ALLEN & HEATH®

TECHNICAL BULLETIN

SUBJECT: FILTER 2 - Intermittent loss of audio output
MODEL(S): XONE:92/X 619578 — X92/X 619777
DATE: June 2016
DOCUMENT: TB1604

AG8626_3 Xone 92 Filter PCB Overlay (PCBA 004-544 illustrated)

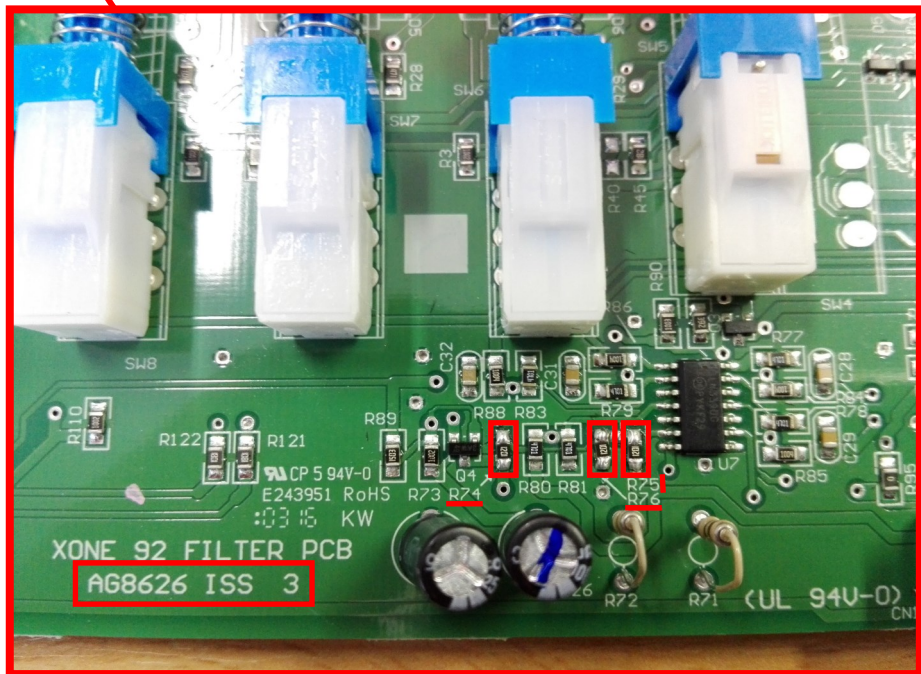
The cause has been identified as component tolerance of transistor [Q4] in the VCF control circuit and a permanent solution is to change the value of three resistors on each FILTER PCB [AG8626_3].

CHANGE value of Resistors: **R74, R75, R76** from 4K7 to **1K2**

De-solder and remove three (3) of: 4K7 [AC3062] - RES SMD 4K7 1% 0805
FIT, three (3) of: 1K2 [AC3059] - RES SMD 1K2 1% 0805

Modification should be implemented for PCBAs:
 FILTER 2: [AG8626_3] - 004-544 PCB ASSY XONE:92 FILTER 2 V3
 FILTER 1: [AG8626_3] - 004-543 PCB ASSY XONE:92 FILTER 1 V2
CHANGE value of Resistors: R74, R75, R76 from 4K7 to 1K2
